SUBJECT: ISSUANCE OF AMENDMENT NO. 2 TO FACILITY OPERATING LICENSE
NPF-76 - SOUTH TEXAS PROJECT, UNIT 1 (TAC NO. 65086)

SAFETY EVALUATION BY THE OFFICE OF NUCLEAR REACTOR REGULATION

SUPPORTING AMENDMENT NO. 2 TO

SOUTH TEXAS PROJECT, UNIT 1

Figure 5.6-1

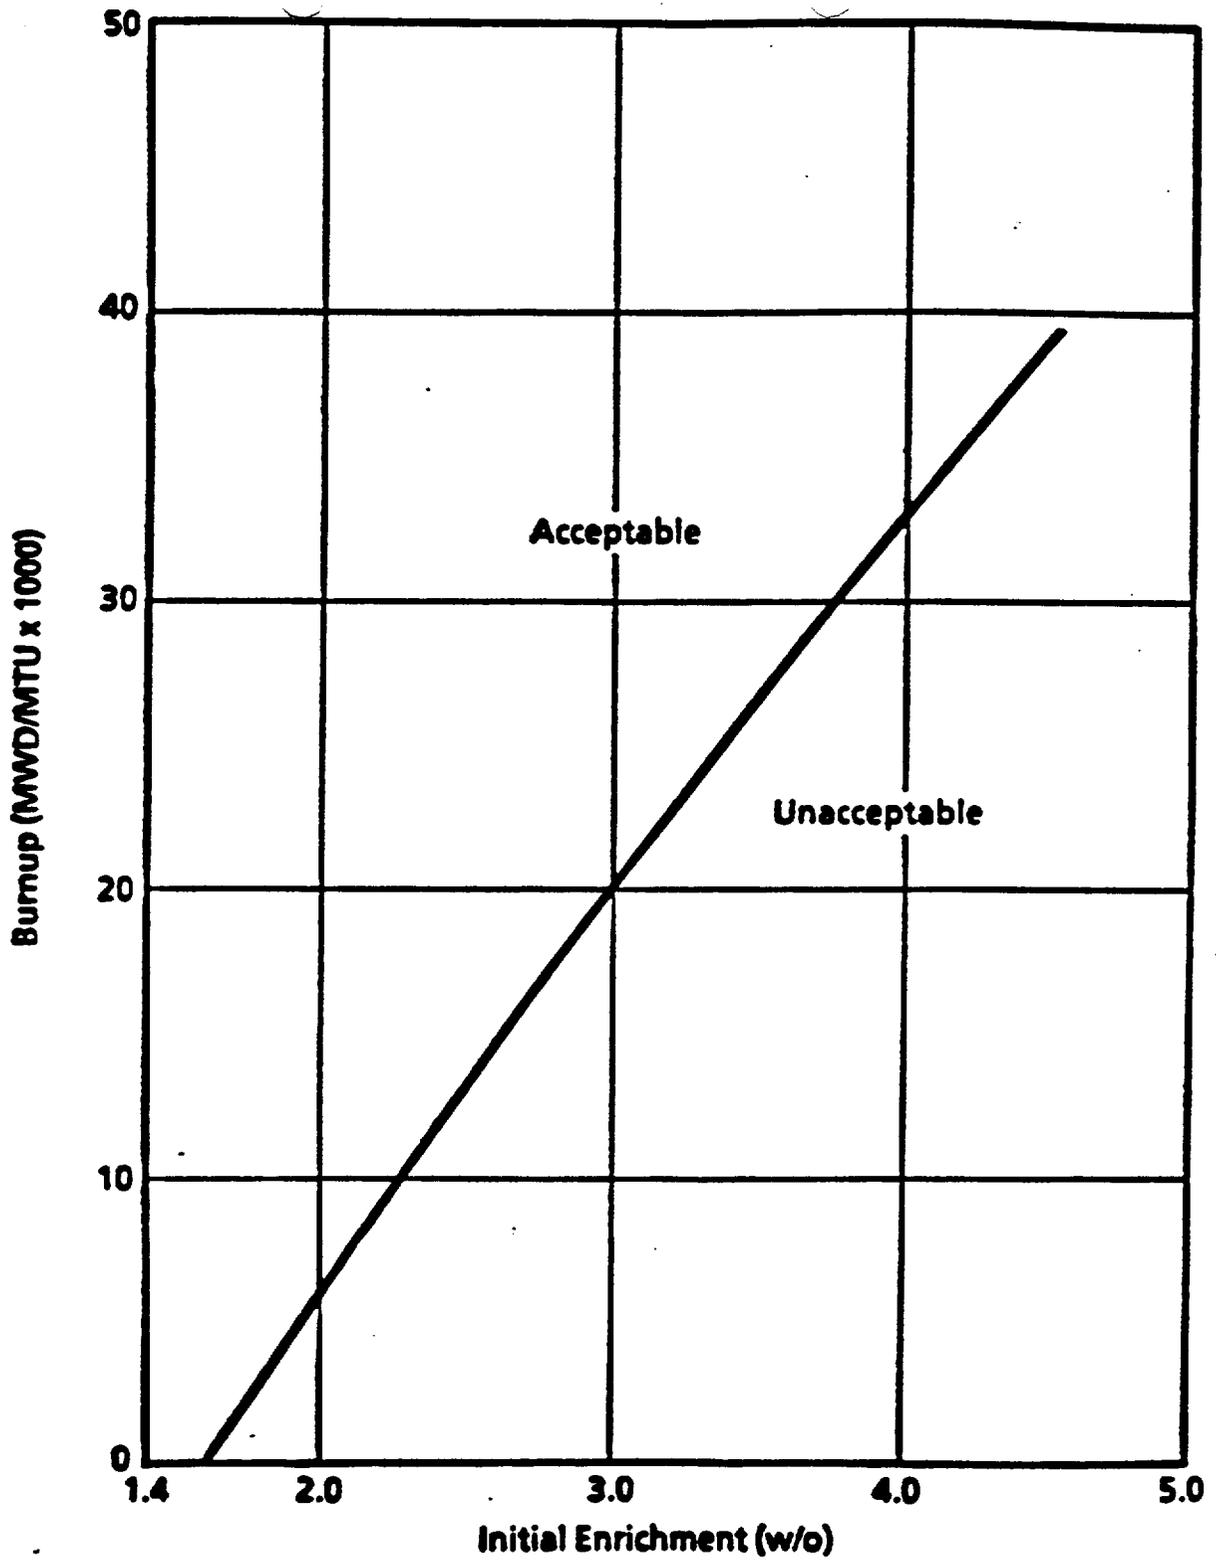
Based on the review described above, the staff finds that the criticality aspects of the design of the South Texas Unit 1 spent fuel racks are acceptable and meet the requirements of General Design Criterion (GDC) 62 for the prevention of criticality in fuel storage and handling. The staff concludes that fuel from Unit 1 may be safely stored in Region 1 provided that the enrichment does not exceed 4.5 weight percent U-235. Any of these fuel assemblies may also be stored in Region 2 provided they meet the burnup and enrichment limits specified in Figure 5.6-1 of the South Texas Technical Specifications.

- Figure 2

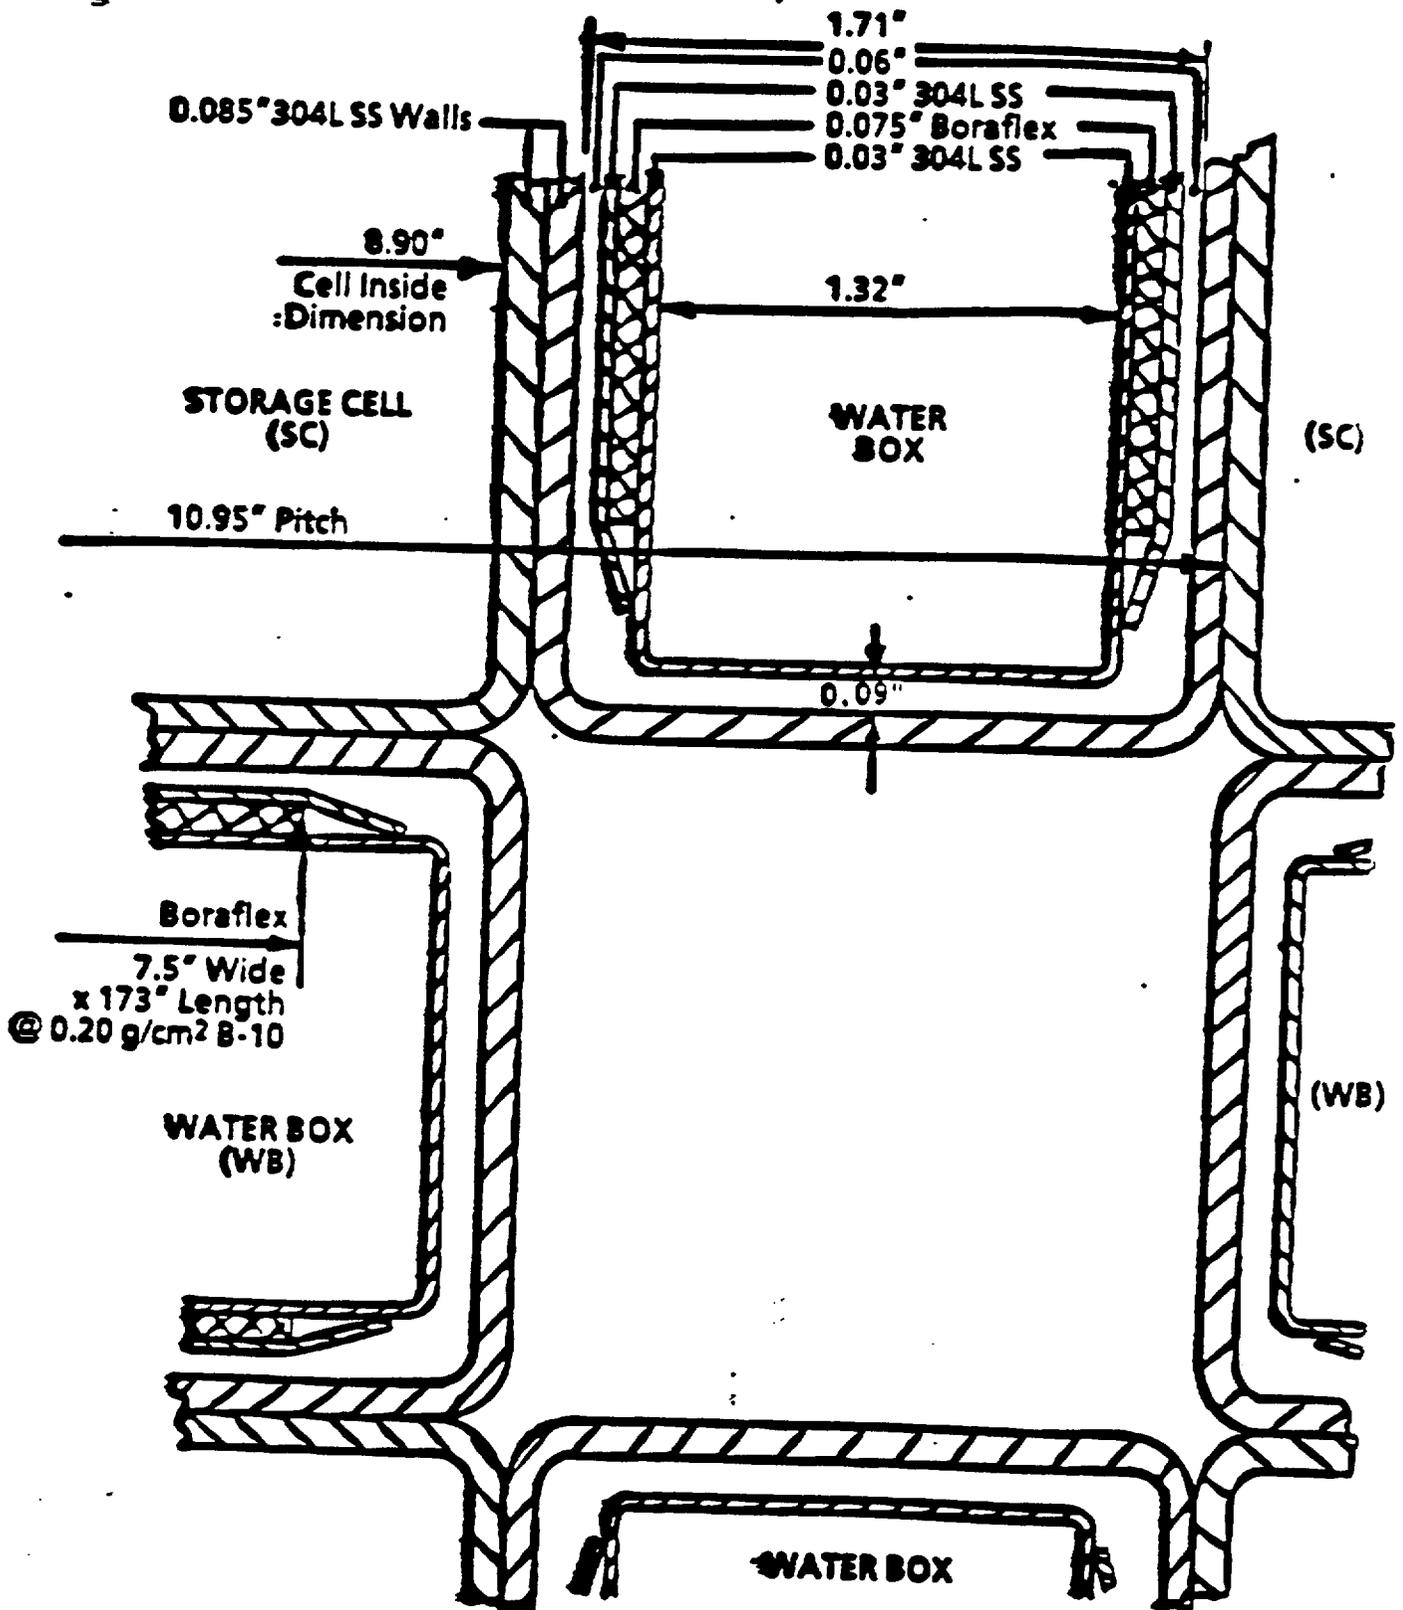
The high-density spent fuel storage rack cells are fabricated from ASTM A240 Type 304L stainless steel plates. The Region 1 racks are a welded honeycomb array of square boxes separated by narrow rectangular water boxes. Strips of Boraflex neutron absorber are affixed on the outside face of the long sides. Stainless steel sheets are welded over the Boraflex sheets to hold them in a fixed position on the box. In Region 2, the Boraflex strips are located between adjacent walls. To provide space for the Boraflex strips between the cells, a double row of matching flat round raised areas are stamped into the side walls of each cell. The cells are welded together at the raised areas to hold the Boraflex in place. The cells are welded to individual assembly bases and to one another. The final rack arrangement is shown in Figure 1. Figures 2 and 3 show the cell design for the Region 1 and Region 2 racks, respectively.

Figure 4

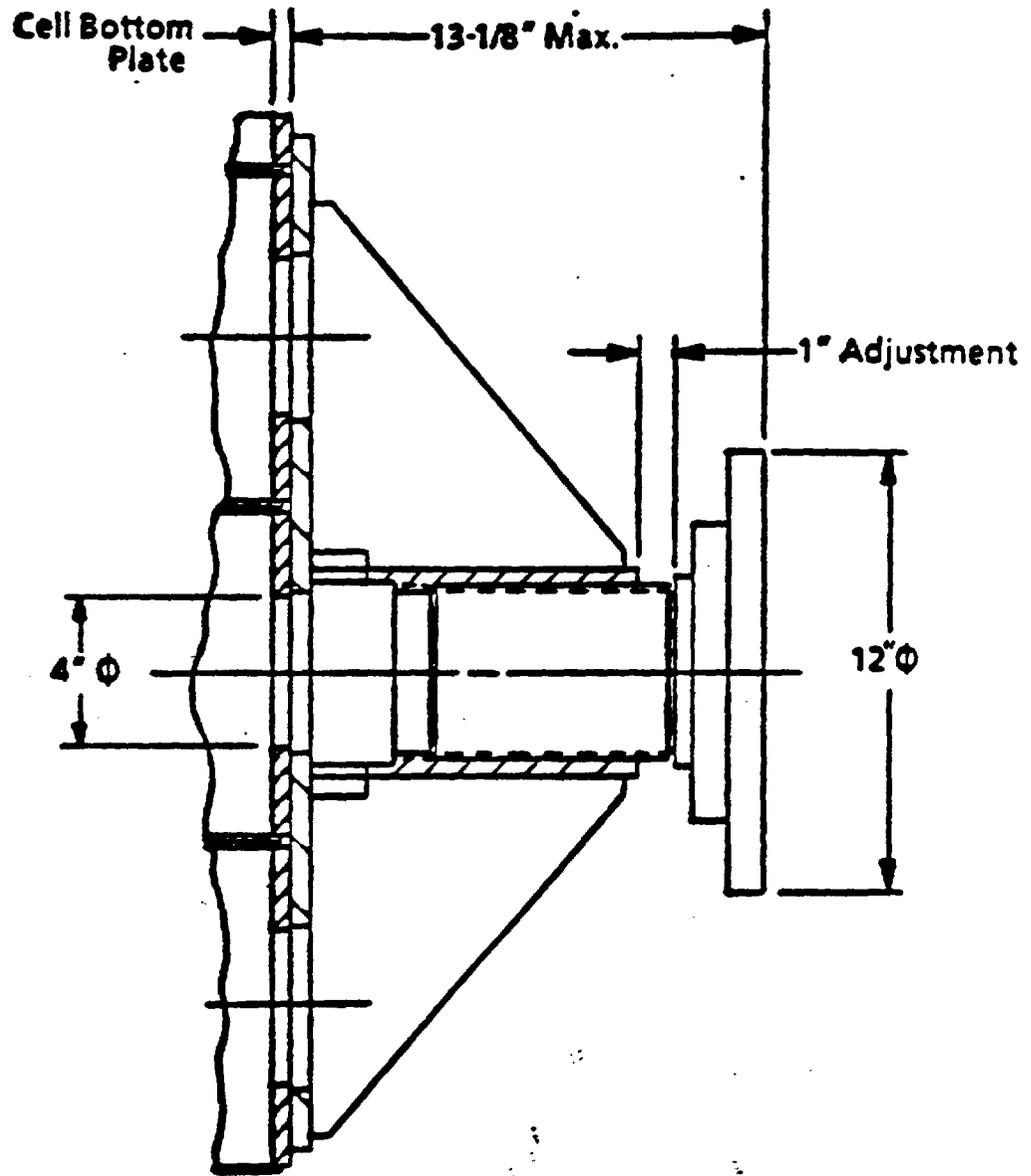
The fuel rack module assembly consists of the storage cells (and integrally welded base plates) welded together and mounted on the support pedestals. The pedestals (four per rack module) are provided with holes and passages for flow to holes in the storage cell bottom plates. Figure 4 illustrates

Figure 5

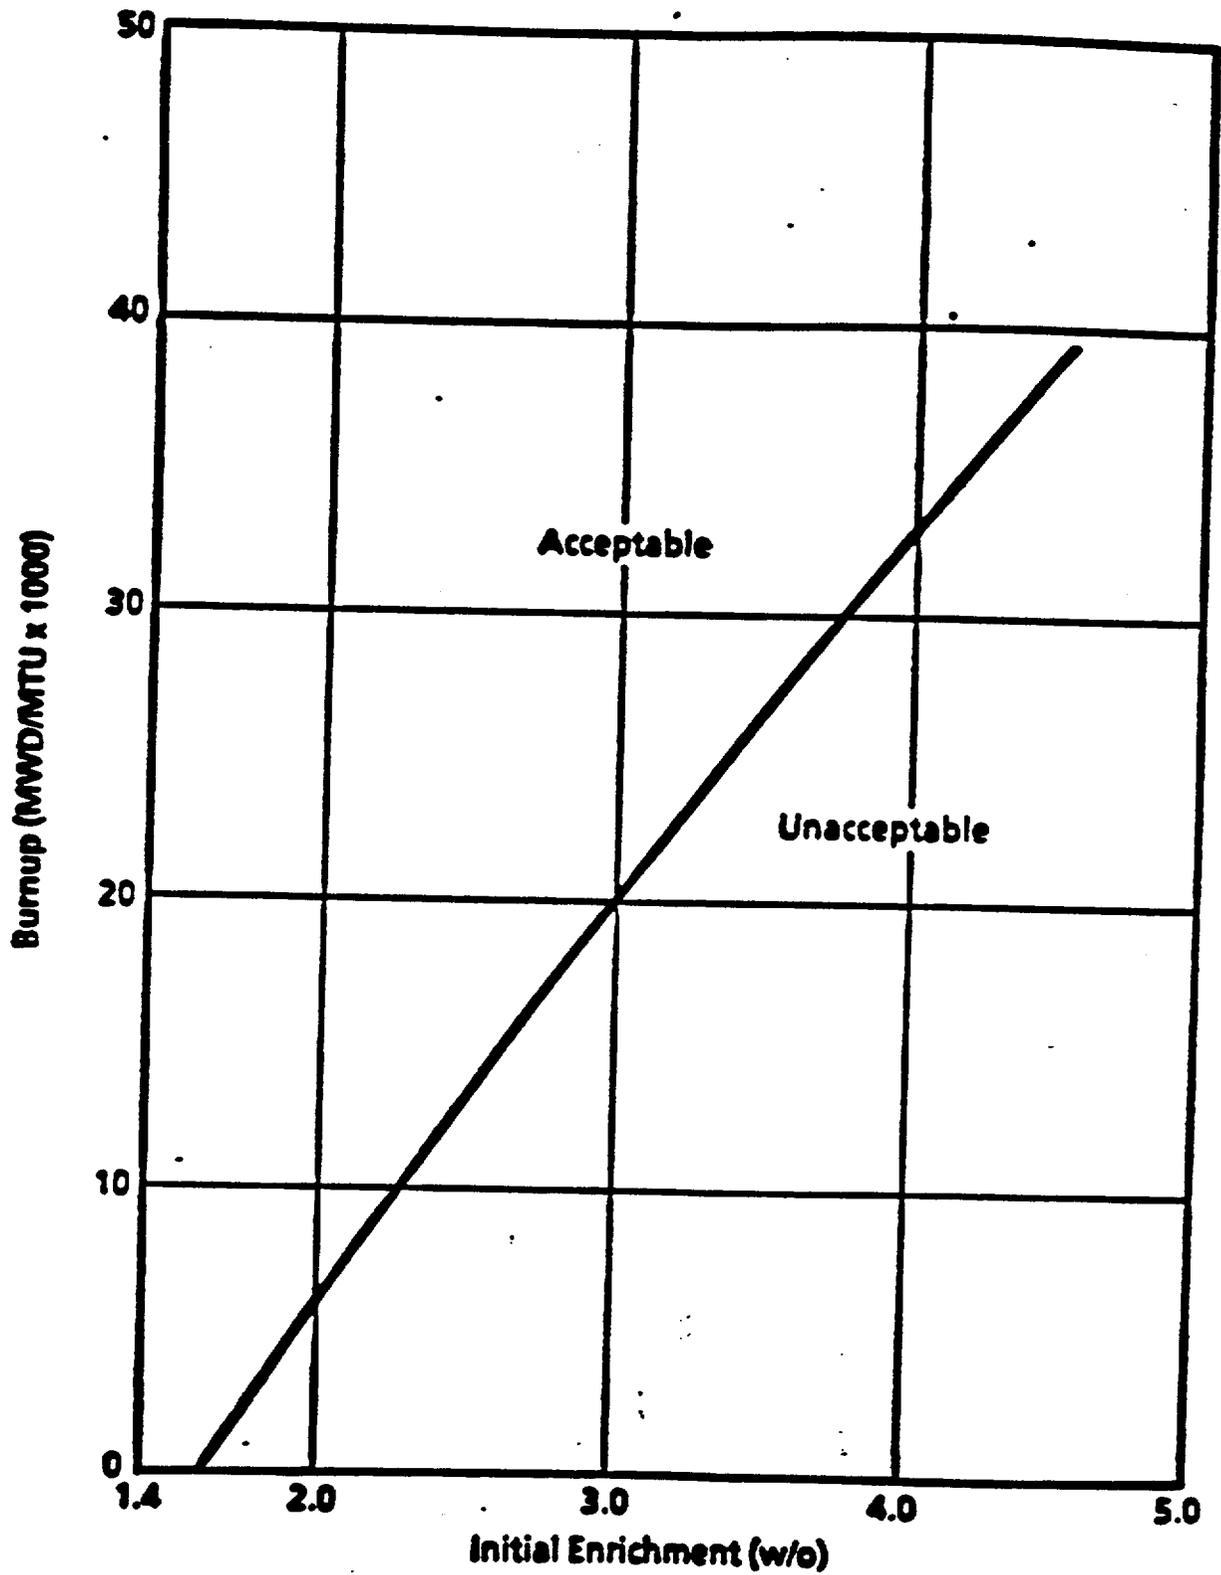
In order to calculate the criterion for acceptable burnup for storage in Region 2, calculations were made for fuel of several different initial enrichments and, at each enrichment, a limiting reactivity value, which included an additional factor for uncertainty in the burnup analysis, was established. Burnup values which yielded the limiting reactivity values were then determined for each enrichment from which the acceptable burnup domain for storage in Region 2, as shown in proposed technical specification Figure 5.6-1 (Figure 5 of this SE), was obtained. The staff finds this procedure acceptable.

For Region 2, the rack multiplication factor is calculated to be 0.9478 for the most reactive irradiated fuel permitted to be stored in the racks, i.e., fuel with the minimum burnup permitted for each initial enrichment as shown in Figure 5. The design will accept fuel of 4.5 weight percent U-235 initial enrichment burned to 40.0 MWD/kgU. The analysis of the Region 2 racks also assumed full flooding by unborated water.
